PUBLIC HEARING MEMORANDUM

PETITION #11-23

78 Crafts Street

78 Crafts Street
Boylston Properties
63 & 67R Court Street
9, 13-19, 24, 31 & 31R Maguire Court
70 & 78 Crafts Street & Assessor Parcel ID 2300160025
Newton, MA
Prepared by: Weston & Sampson Engineers Inc.
Dated: 10-13-2023
Latest Revision: 12-7-2023
&
Drainage Report

Site Plan | Existing Conditions

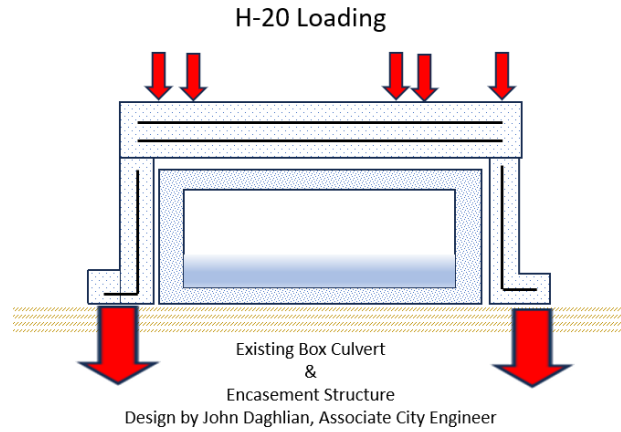
Vehicular access for this development is proposed on Maguire Court (a private way) located off Crafts Street and portions of the proposed 24-foot-wide driveway transverses a City Drain Easement. Since Maguire Court is a private way the abutting properties have ownership rights to the centerline of the layout, this will require access rights for the development between the private parties involved, any agreement should be recorded at the Middlesex Registry of Deeds and proof of the recording shall be given to the City.

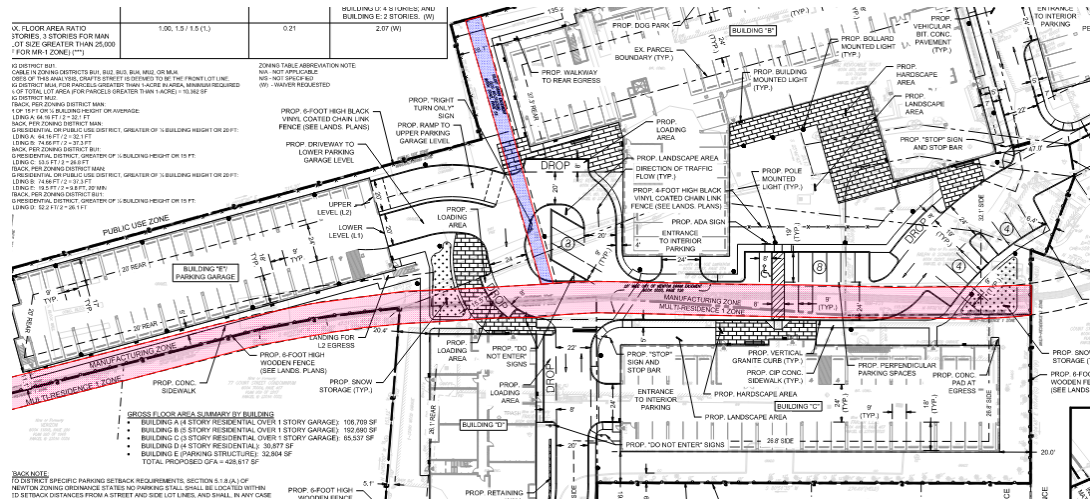
The existing concrete box culvert [36" x 48"] within the City easement was constructed in 1925; it was not designed for vehicular traffic, let alone moving trucks, trash & recycling trucks, and fire vehicles. The culvert is very shallow and just has about 1 foot of cover over the top and in some portions is full exposed (see photo below). If this permit is approved the applicants' engineers will need to either replace the culvert that must be designed for H-20-wheel loading and/or design an encasement structure that would transfer the truck/traffic load off the existing culvert and transfer the anticipated loads to the surrounding soils as shown in the following schematic.

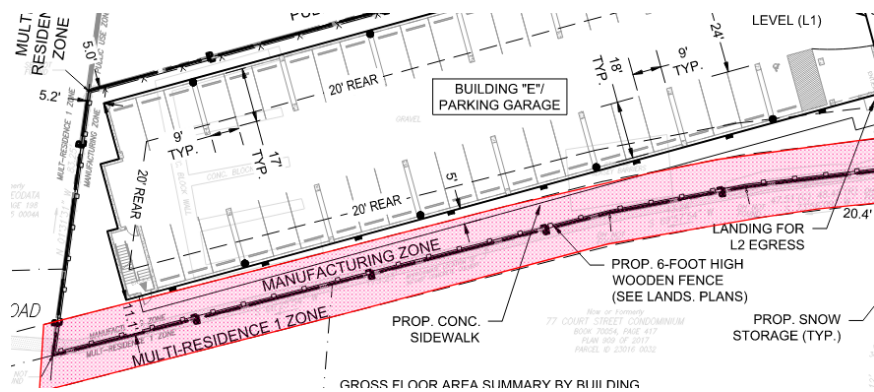
The proposed design has several encroachments within the City easements which would need License Agreements that clearly defines the nature of the encroachments, materials, maintenance, and indemnification of the City if and when DPW crews or contractors need to access the culvert at any time. There are two City easements highlighted below.

DPW also has a concern regarding the placement/construction of the proposed 2 story parking garage. The footprint of the garage is within inches of the easements and the unknown location of the culvert, the applicants engineers need to develop a construction feasibility study to be reviewed by the City and its consultants on means and methods of how the excavation for the foundation of the parking garage will be secured, shored and made safe so as not to cause harm to the culvert that must be maintained in perpetuity without impact to the flow nor cause flooding on or off site. This feasibility study shall include a detailed site that delineates the actual limits of the existing box culvert alignment and the easement.

Sheet C 101:

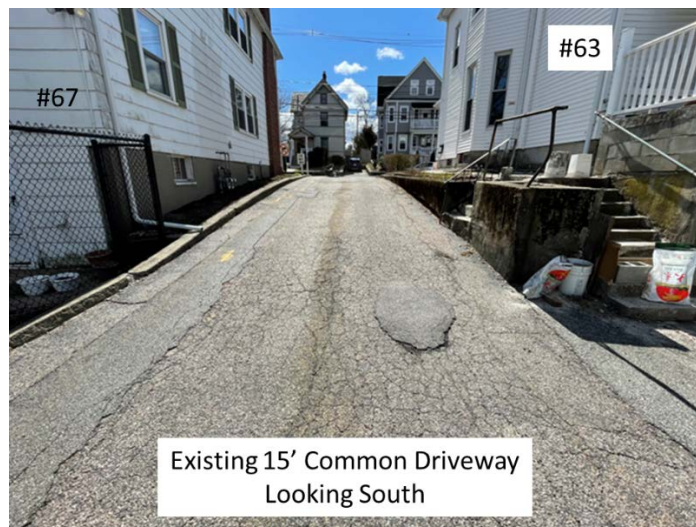
1. A second egress driveway (20' – 24' wide) is proposed that will connect from the proposed turning circle and extend towards Court Street. The northern portion of the

driveway will provide access to the two proposed buildings C & D and will be available for Fire & emergency vehicles that may enter from the south or Court Street.

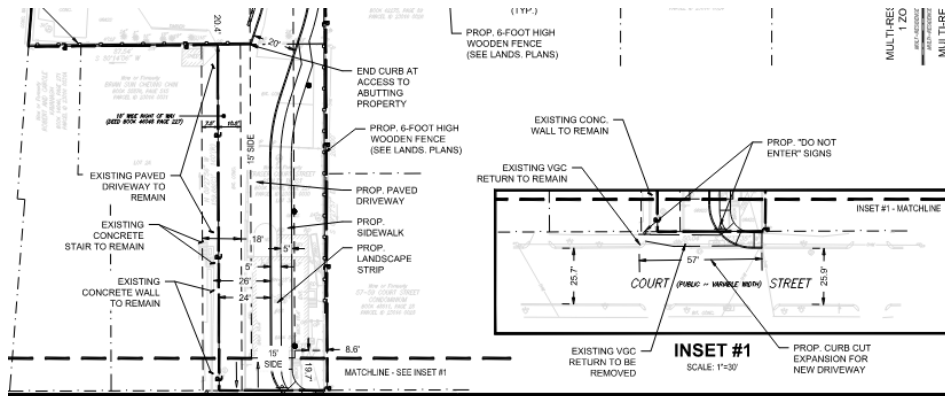
2. The proposed driveway is shown to be 20-24 feet wide and will be located between #63 & 67 Court Street which share a common driveway. The existing driveway measures just under 15-feet wide, #63 also has a 4-foot-high retaining wall and access stairs that are to remain (according to the notes); however, they are not shown on the site plan. The plans need to be updated to show these features to ensure adequate maneuverability and safe integrity of the wall and stairs. According to the demolition plan it appears that #67 will be razed; however, on this sheet it is not clear as how the new driveway will encroach onto this former lot.

3. On insert #1 a sign is to be placed that states "DO NOT ENTER"; what will deter the people living in building B & C or any of the other buildings from entering from this

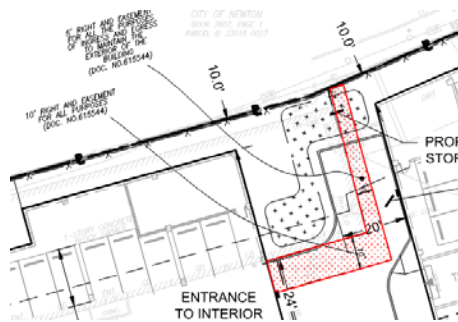
driveway, who will police this activity? How will general access be prohibited from using this for access to the development?

- There are two notes that state “5’ & 10’ right & easement for all the purposes of ingress & egress to maintain exterior of the building”. Why would these be needed as the entire site/lot should be under one ownership, and why is it limited to just this little sliver on the property between buildings A & B? Who is the easement being granted to?

- Three very modest snow storage areas are shown on this plan for a site that has over 700 feet of roadway and sidewalks, this seems very under sized.
- The proposed roadway needs stationing starting with 0+00 at the intersection of Crafts Street and extending westerly to the turnaround and a separate station plan for the common driveway going toward Court Street. Additionally, all utility structures should have a stationing and offset from the centerline of the roadway.
- The proposed pedestrian crossing between building B & C should be a raised crossing to keep vehicle speeds down and ensure safe pedestrian access.

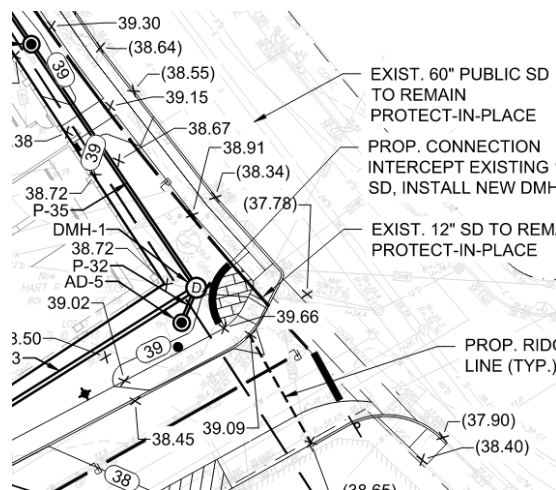
8. Drop zones should have ADA & AAB compliant pedestrian ramps for universal access for pick/delivery of passengers.
9. On insert #2 near the proposed monument sign the existing utility pole has a severe lean that should be addressed for both safety and aesthetics.

10. The sidewalk on the western side of building C needs an additional pedestrian ramp reciprocal to the south side.
11. The site plan does not indicate where trash & recycling dumpsters will be located? Will they be in the garages of each building, if so, are they rollout type?
12. US Mail delivery & parcel drop offs, will these be in one centralized building, or will each building have its own "mail room"? This needs to be verified with the US Postal Service.
13. A dog park is proposed behind building B, is this dog park exclusive to the building B dog owners or is it open for the entire complex, and/or the neighborhood? How would a dog owner from building A, C & D access this park? How will trash generated from this park be addressed? What is the proposed surface of the dog park, will it need an under drain?
